Service Bulletin

Bulletin No.: 25-NA-051
Date: March, 2025

Subject: Tire Pressure Monitoring Sensor (TPMS) Intermittent Signal Loss

Brand:	Model:	Model Year:		Build Date:		Engine:	Transmission:
		from	to	from	to		
Chevrolet	Blazer EV	2025	2025	SOP	October 17, 2024		
	Equinox EV			September 19, 2024	November 28, 2024

6857497

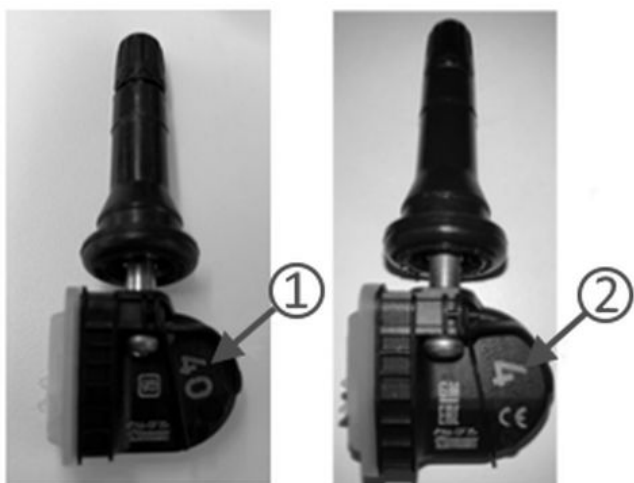
The TPMS sensor p/n location is shown in the graphic above.

Remove the sensor that is exhibiting the above concern and check the p/n on the sensor.

- If the p/n is 13542674, replace the sensor and all other sensors with p/n 13556202.
- If the p/n is 13556202, refer to normal SI diagnostics.

The graphic above shows one other way to identify if the TPMS sensor, the old part is stamped with a 40 (1) and the new part is stamped with a 4 (2).
